TE1163-TE-00-XX-GE-LT-008-V01

TIER RESPONSE TO NATIONAL HIGHWAYS LETTER REFERENCE: NH/23/02241

SYMMETRY PARK
CRANTON
PHASE 1 - UNIT 2

FORMER CRONTON COLLIERY

Drawing Ref: L005-TIE-ZZ-XX-DR-C-6036

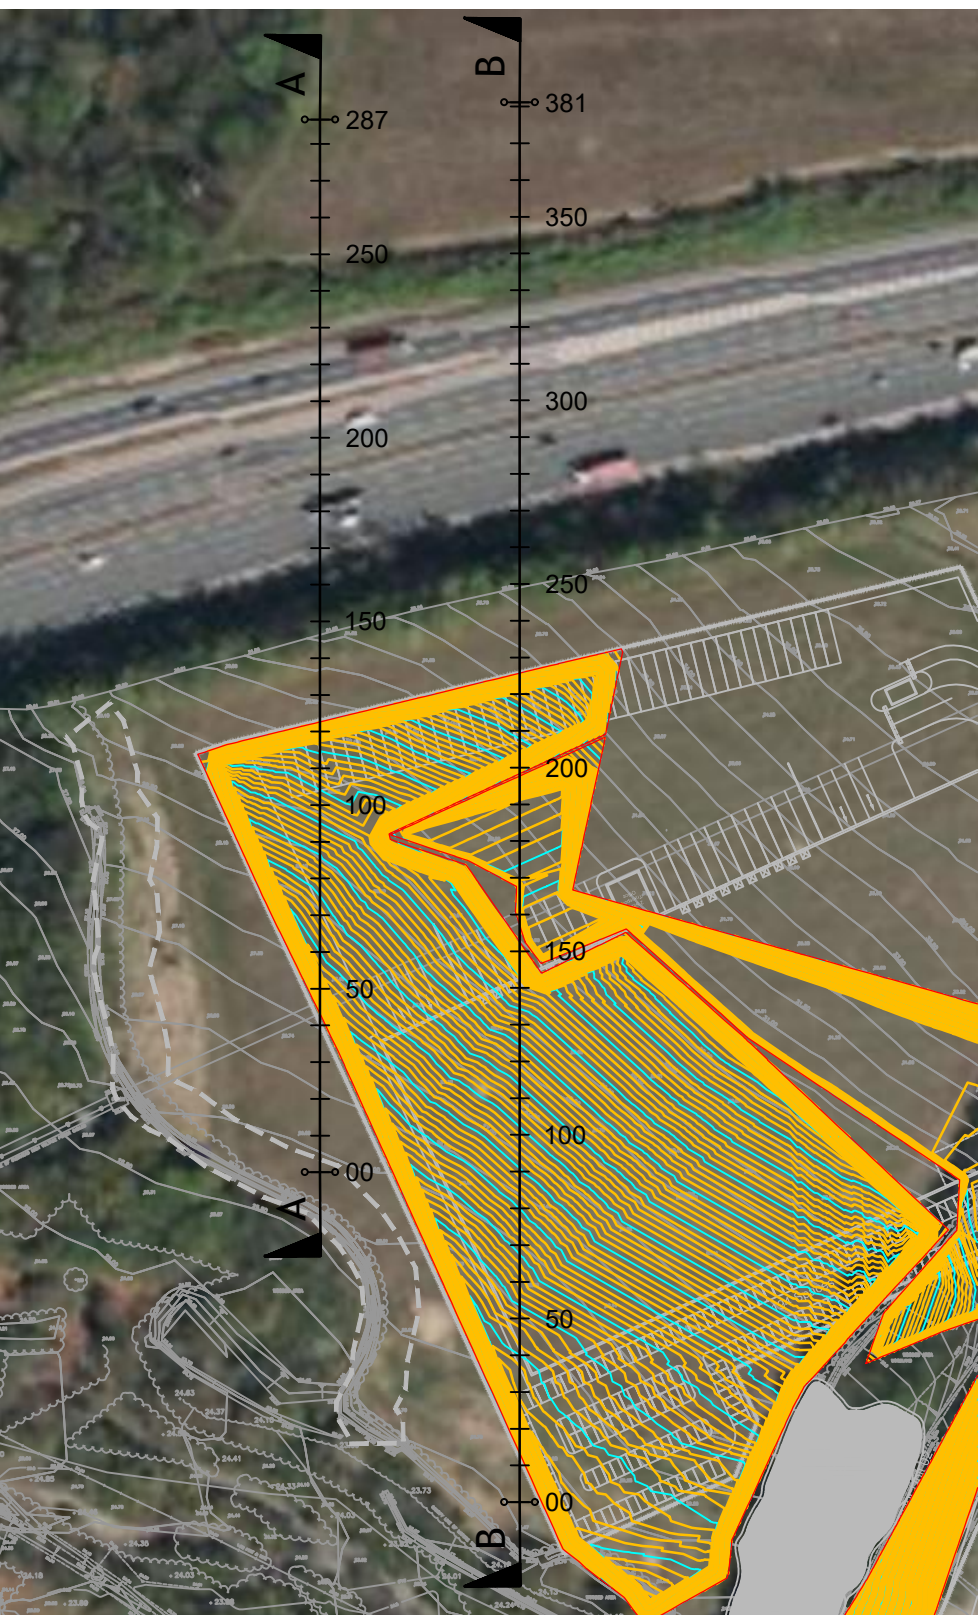
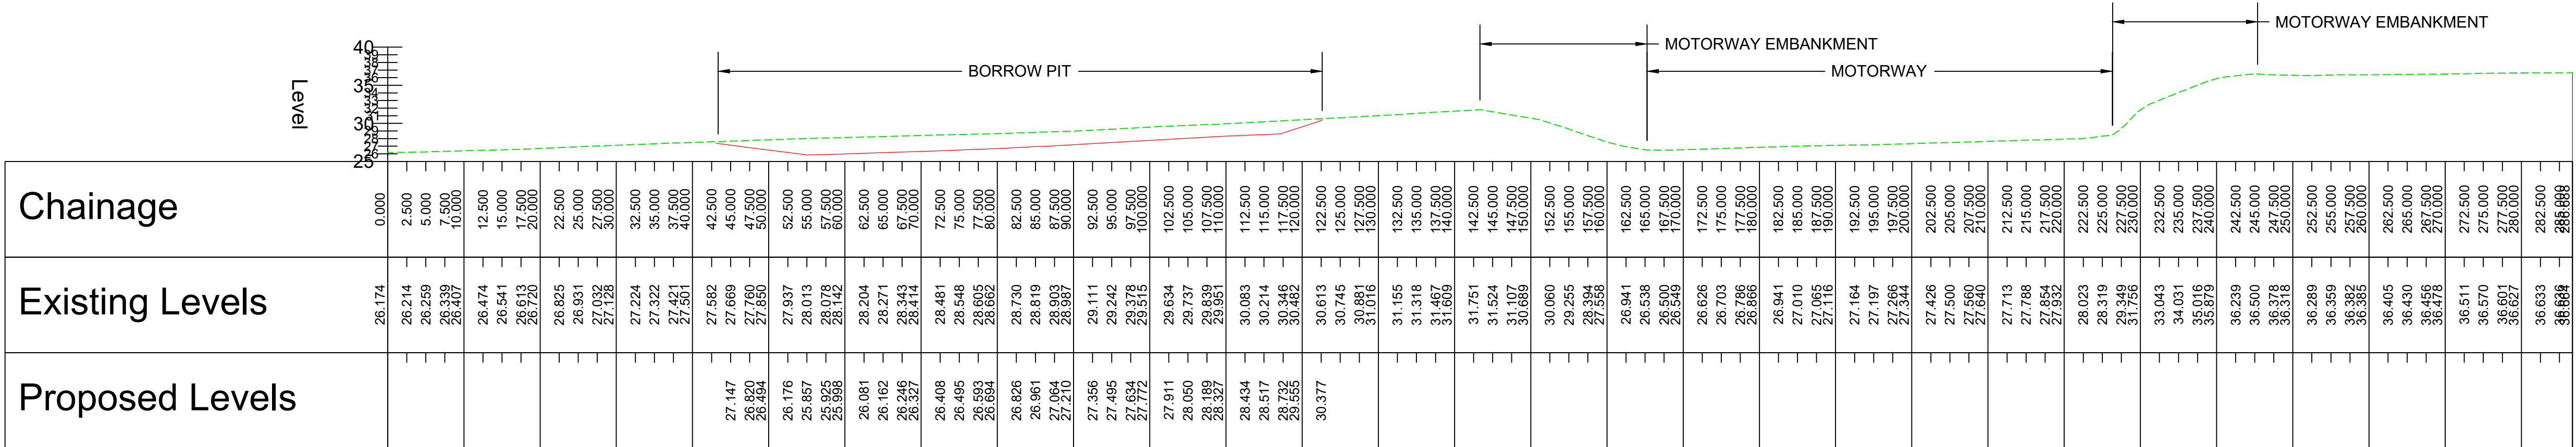
Details of the borrow pit and its impact on the M62, including any relevant slope stability assessment. (If necessary, the northern extent of the pit may have to be moved a safe distance away from the M62).

Appended to this letter Tier have included further drawings and sections of the proposed excavations. As can be seen on drawing No: L005-TIE-ZZ-XX-DR-C-6036, the edge of the excavated area is approximately 30m from the edge of the site boundary / top of motorway cutting and over 60m away from the edge of the carriageway. At this distance it is not considered to be within influencing distance of any National Highways infrastructure. Furthermore as shown on the above referenced drawings, the excavated area will be a maximum of 1.75m bgl deep. At the northern extent of this area, this equates to a formation level of 28.75m AOD compared with a carriageway level of 26.50m AOD on the M62.

All excavations in this vicinity of the site will be undertaken in predominantly natural soils. Ground investigations have shown these materials to comprise of Till Deposits, consisting of mainly firm clays, and Pennine Coal Measures consisting of largely mudstone. Investigations have also confirmed that excavations undertaken in this vicinity of the site were stable, with no collapses noted in exploratory trial pits. Bedrock is recorded at a shallow depth in this vicinity of the site generally a maximum of 4m bgl. If the superficial soils were to fail, using a conservative 45-degree angle for an approximate zone of collapse, the failure would only impact an area a maximum of 4m away from the edge of the excavated area.

Additionally the sides of the excavated area will be sloped at a very shallowly dipping angle of 1 in 3 to further reduce the risk of any slope failures and if required materials will be mixed with lime to

reduce moisture contents. Tier will also be undertaking regular site visits to monitor the progress of the works including inspections of the sides of the excavations.

Due to the reasons detailed above and contained within the appended drawings, it is not considered that any of the proposed excavations undertaken within the site boundary will have any impact on any National Highways Infrastructure.

GROUNDING PLAN

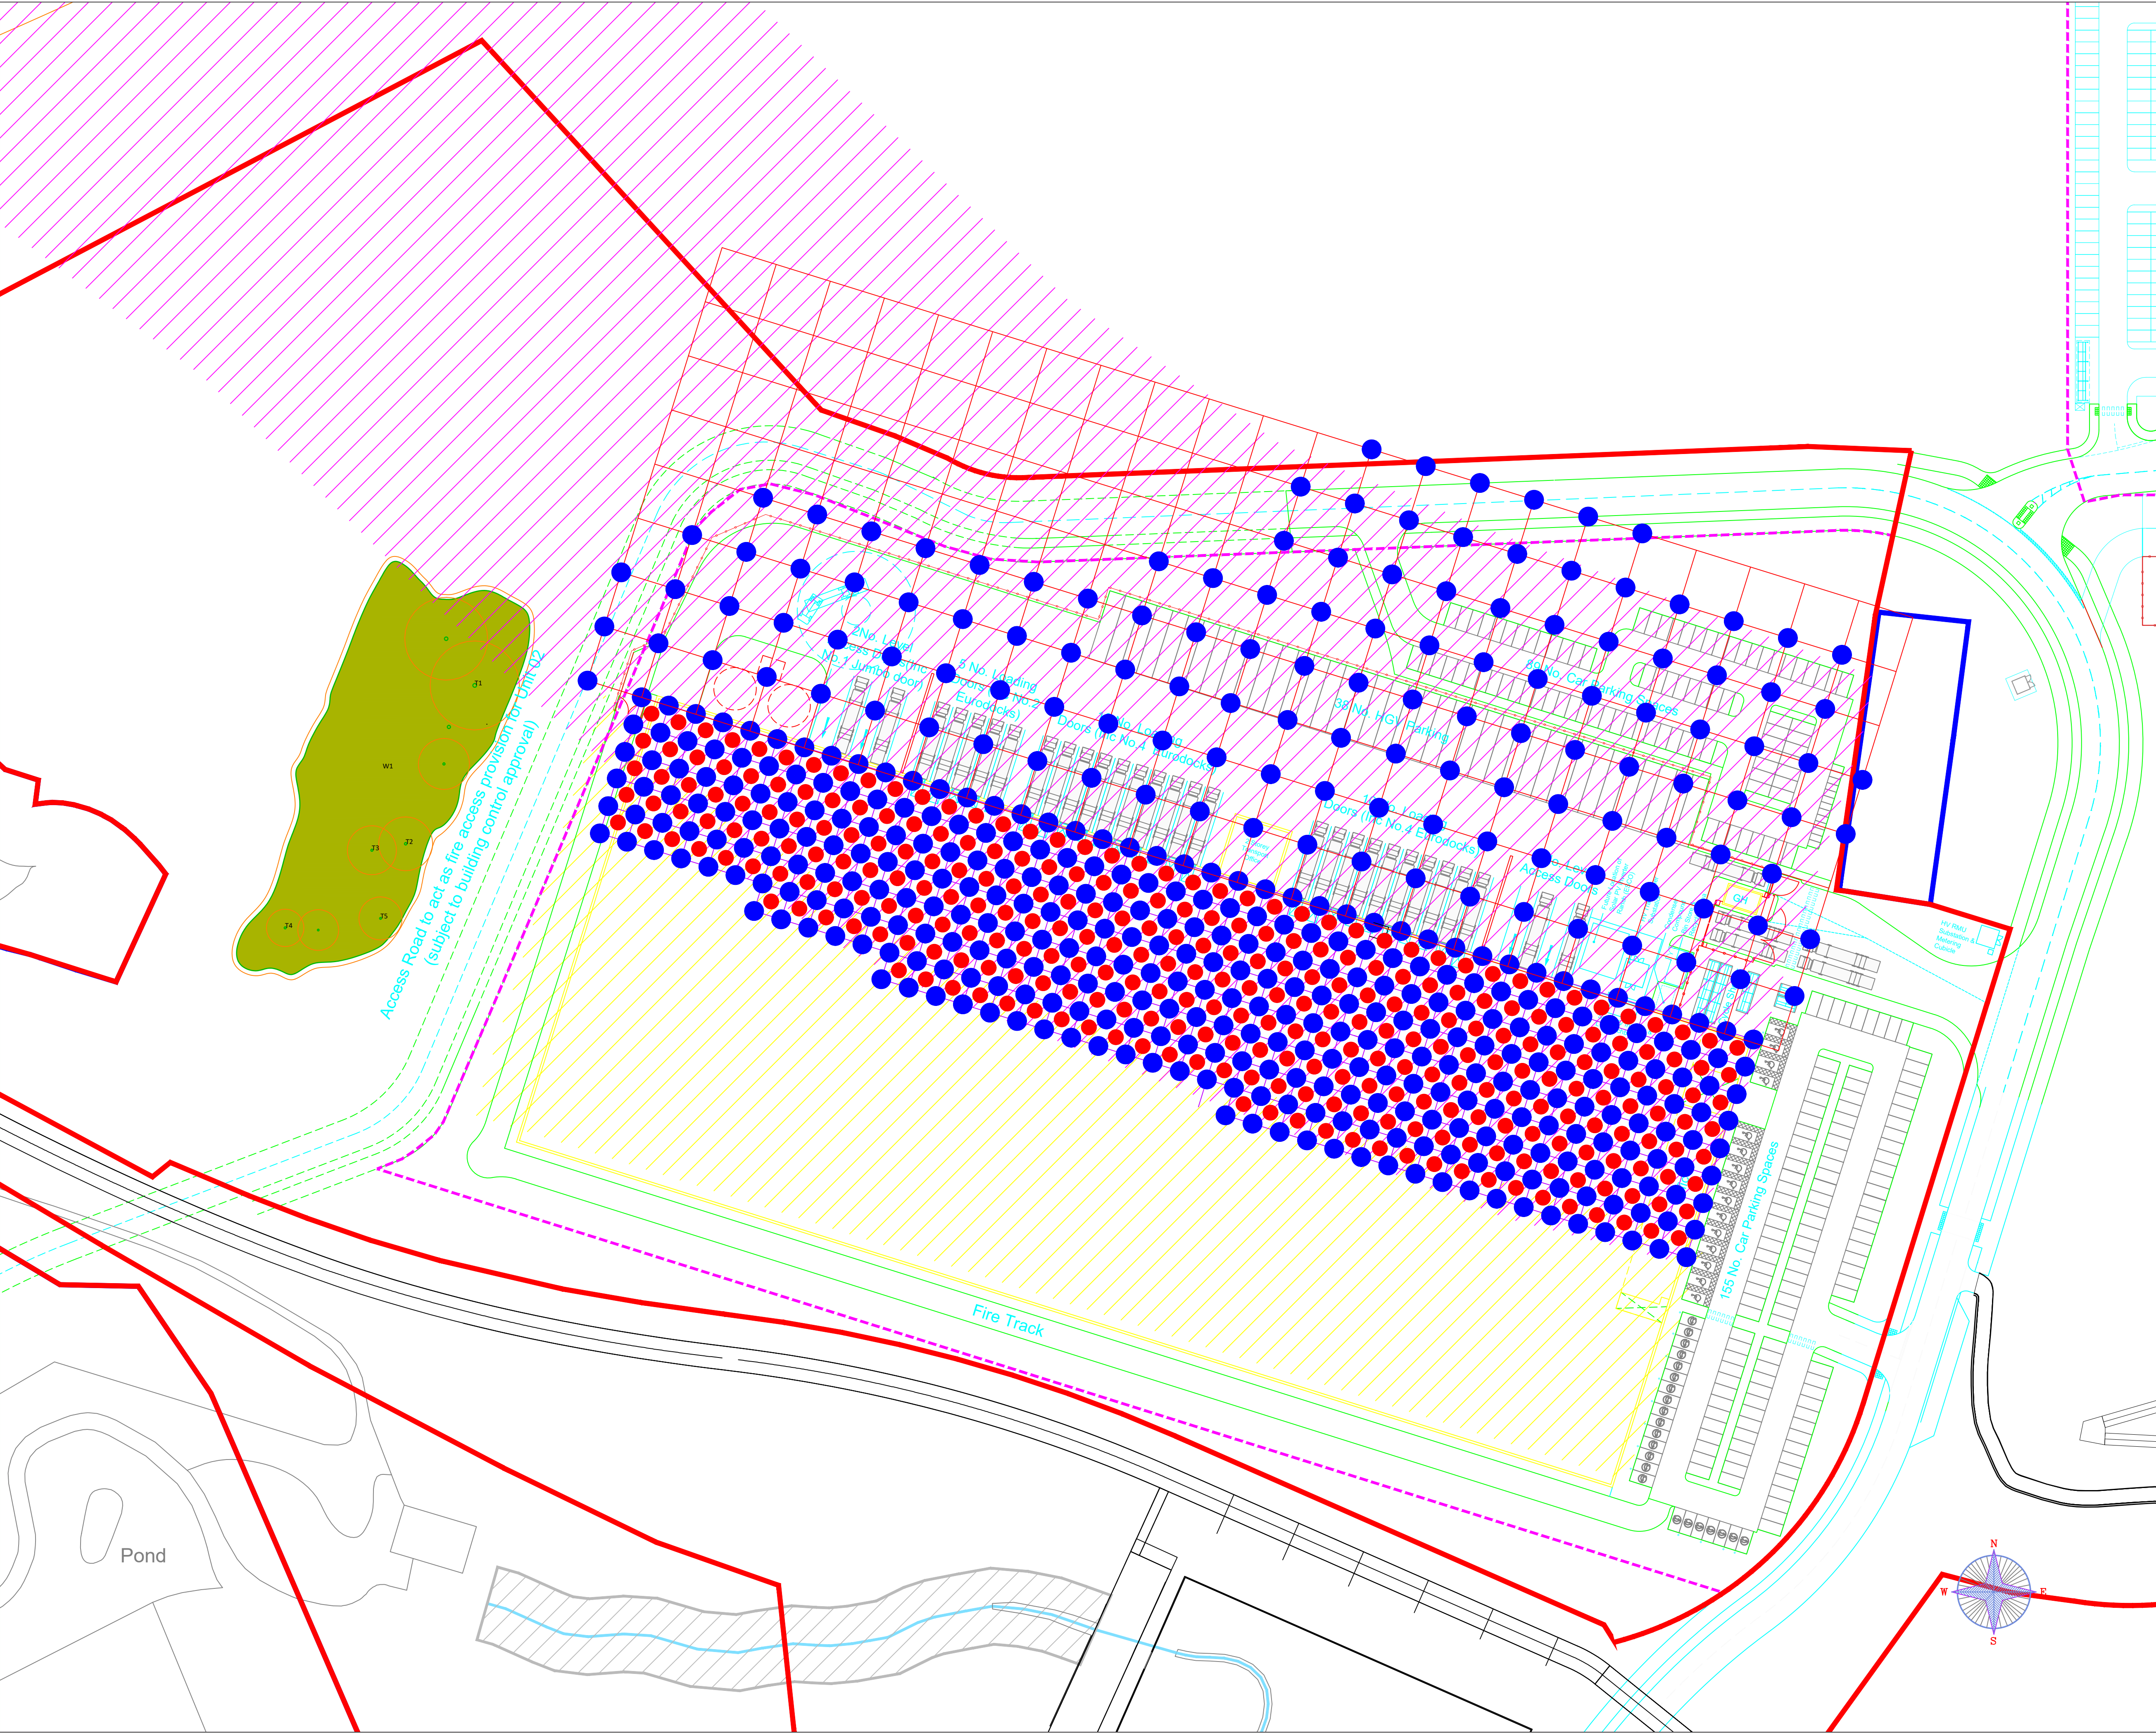
Confirmation of the drilling and grouting zone at the site. Depending on its proximity to the M62, its impact on the motorway.

The drill and grouting zone during this phase of the development will be over 215m away from the M62 and is not considered to pose a potential impact on any National Highway infrastructure. The drill and grouting plan is appended to this letter.
